Re: Proposed Spencer Pit (Guelph 635.06-4586)

Our Project # 10-47

Further to your email dated January 13, 2014, we are pleased to provide clarification on the following details regarding the proposed Spencer Pit site plans.

SECTION 1

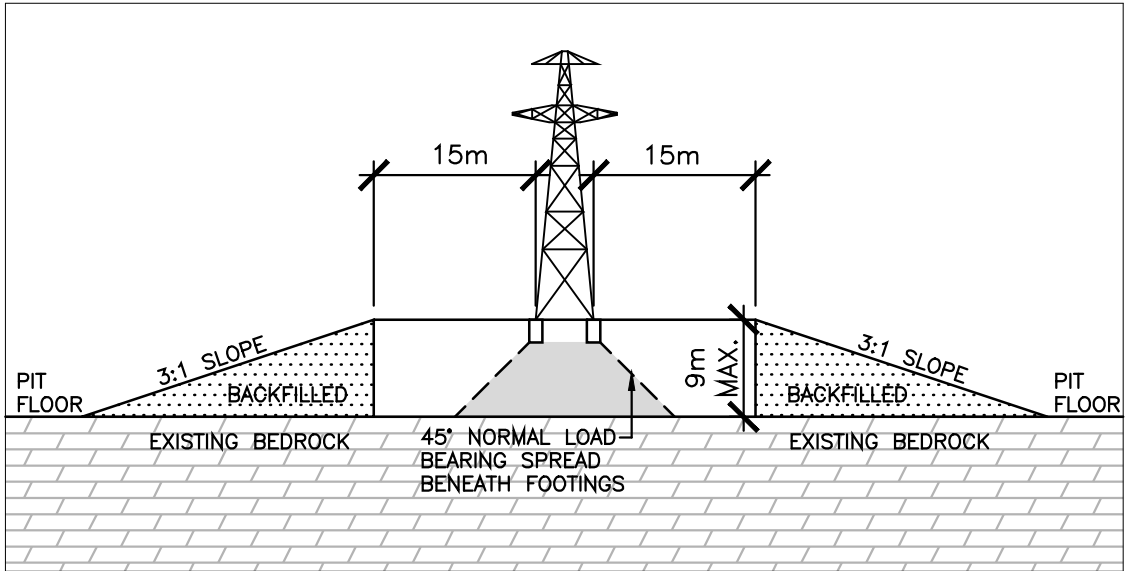
4. *The proponent should provide cross sections of the access route for Hydro One maintenance vehicles, indicating that slopes that the vehicles will need to traverse. The slopes of this road should not be steeper than 10:1.*

We have added a section of the access road to be provided to all towers.

SECTION 2

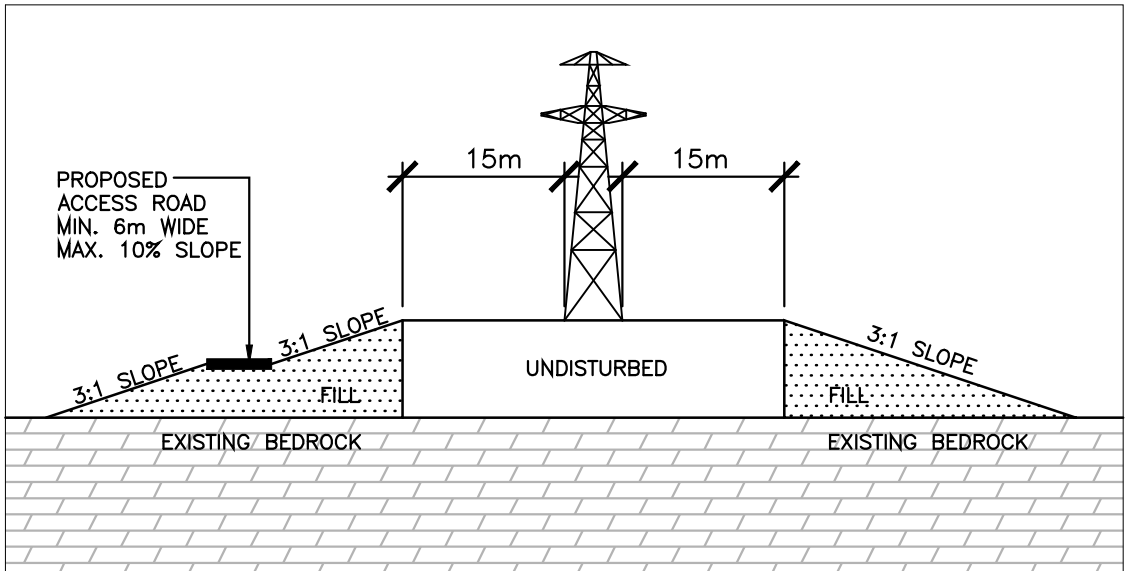
6. *Proper anchor and footing stability must also be maintained.*

As mentioned earlier, the typical standard for footing stability is 45° from the bottom of the footing, or a slope of 1:1. Assuming a footing depth of 1.5m, this would be 8.5m above bedrock in the worst case. A setback of 8.5m would therefore be sufficient in the spot and less everywhere else. The setback of 15m is therefore almost twice what is required. We have provided a section of this area of tower 53, which is the highest (worst case) tower.
